Office Action Summary

10/519,279

RODDIS, ALAN JAMES

DETAILED ACTION

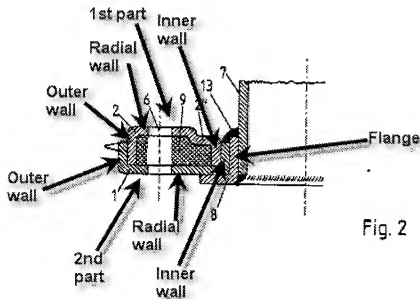
3. Claims 1, 4-7, 10-12 and 14-15 are rejected under 35 U.S.C. 103(a) as being unpatentable over Kirchkamp (DE 2838514 A1).

Kirchkamp discloses a mechanical seal (figure 2) having a gland plate (e.g. plate formed by 1, 2 and 9 attached to form a seal on 7). The gland plate has structure claimed by applicant in claims 1, 4-7, 10-12 and 14-15.

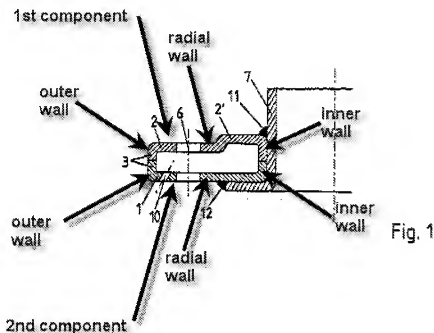
Kirchkamp further discloses the gland plate comprising a rigid, annular element comprising at least one two axially radially extending walls (e.g. radial wall of 1 and 2 of figure 2) having a thickness, the radially extending walls having a center orifice (e.g. center orifice that receives 8) in the center of the radially extending walls and an outer circumferential perimeter extending around an outer edge of the radially extending walls, an outer wall extending axially and continuously between the radially extending walls and around the outer circumferential perimeter of the radially extending walls (e.g. see above figure), an inner wall extending axially and continuously between the radially extending walls (inner walls of figure above) and around the center orifice, at least one additional orifice (e.g. 6 in the radially extending walls) formed in the at least one two radially extending walls between the center orifice and the outer circumferential perimeter of the radially extending walls. The respective inner circumferential walls and respective outer circumferential walls of the first and second components are brought into juxtaposition and held in engagement to form a hollow, annular structure, the respective

orifices of the first and second components are aligned to form at least one bolt hole (e.g. additional orifice) and the respective circumferential flanges of the first and second components abut (intended use, the first and second component are capable of being juxtaposition). The flanges are defined by the inner walls that form the orifices. The element is filled with concrete, plastic or water (e.g. material of 9).

Regarding the limitations of plastic in claims: Kirchkamp discloses the claimed invention except for the material 9 to be plastic, concrete or water. It would have been obvious to one having ordinary skill in the art at the time the invention was made to have the synthetic material of Kirchkamp to be replaced by plastic or concrete, since it has been held to be within the general skill of a worker in the art to select a know material on the basis of its suitability for the intended use as a matter of obvious design choice. In re Leshin, 125 USPQ 416.
